FROM: Rebecca Ballo  
Historic Preservation Section Maryland-National Capital Park & Planning Commission  
Historic Area Work Permit #1054192 - Revisions to retaining wall treatments associated

SUBJECT: with shared use path.

**Case Number:** 1054192

**PROPOSAL:** Revisions to retaining wall treatments associated with the previously approved shared-use path.

REVIEWED  
By Rebecca Ballo at 1:50 pm, Jan 26, 2024

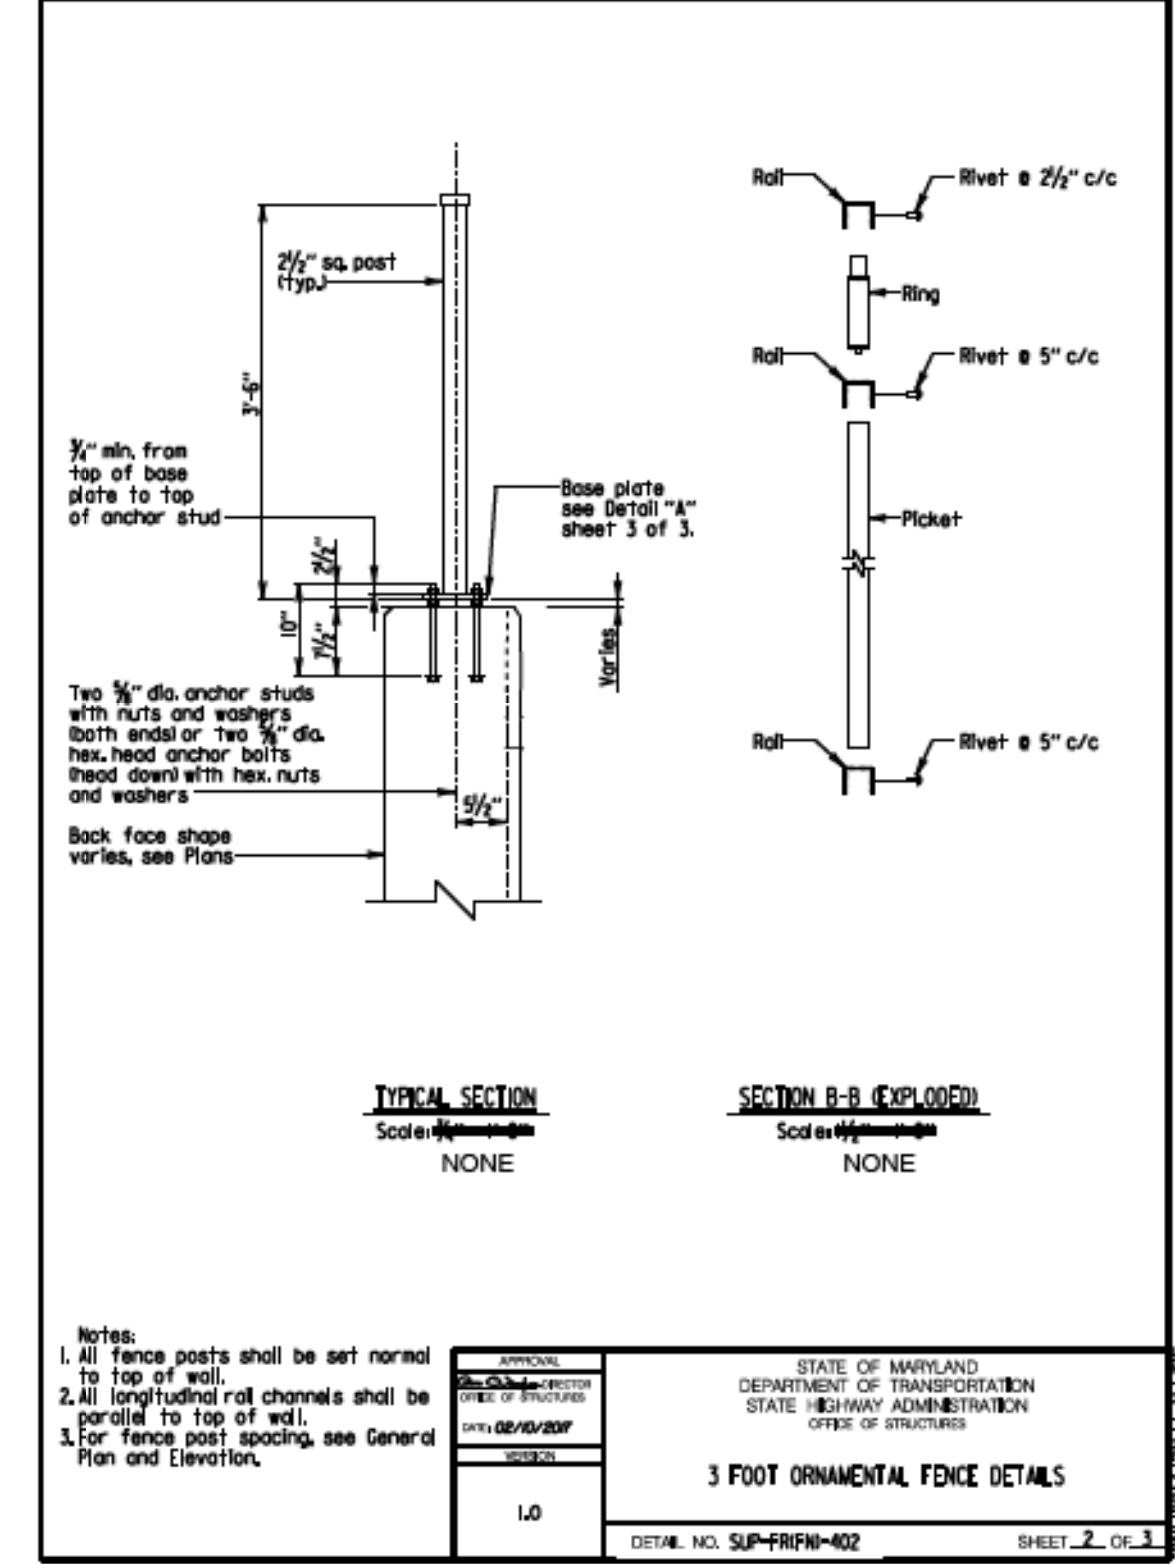
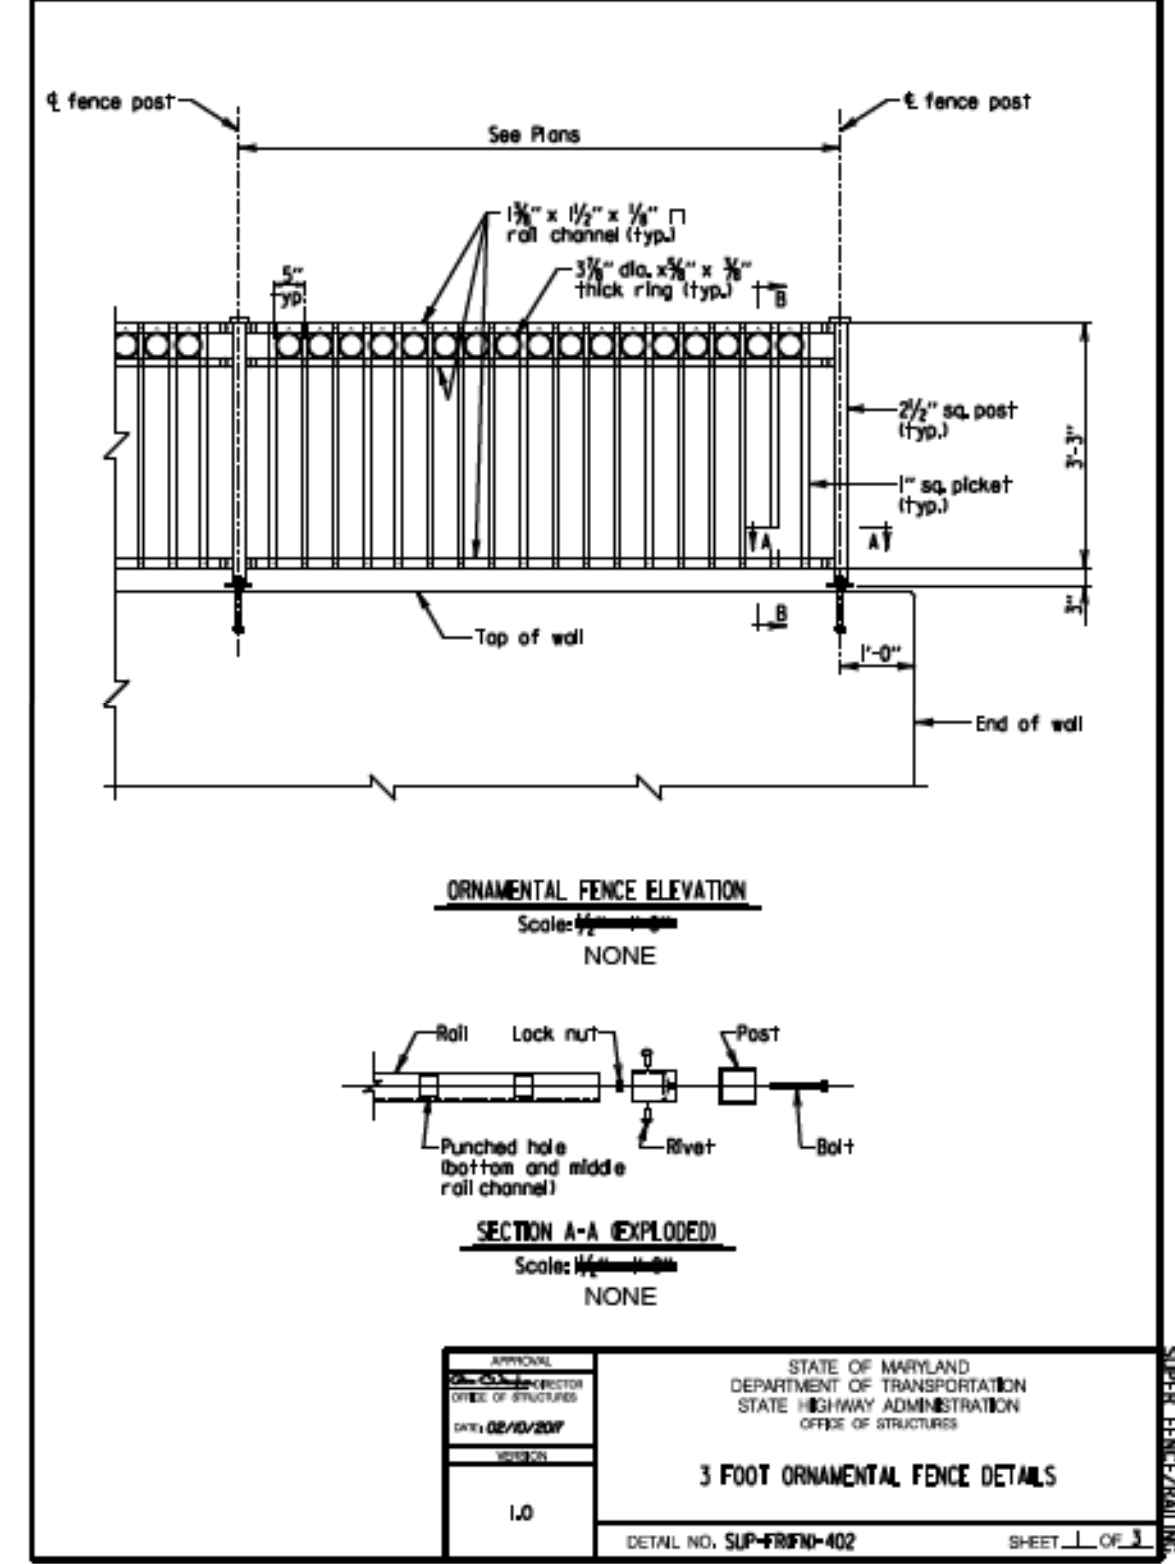
The Stone Facing is approved, NOT the white textured block face.
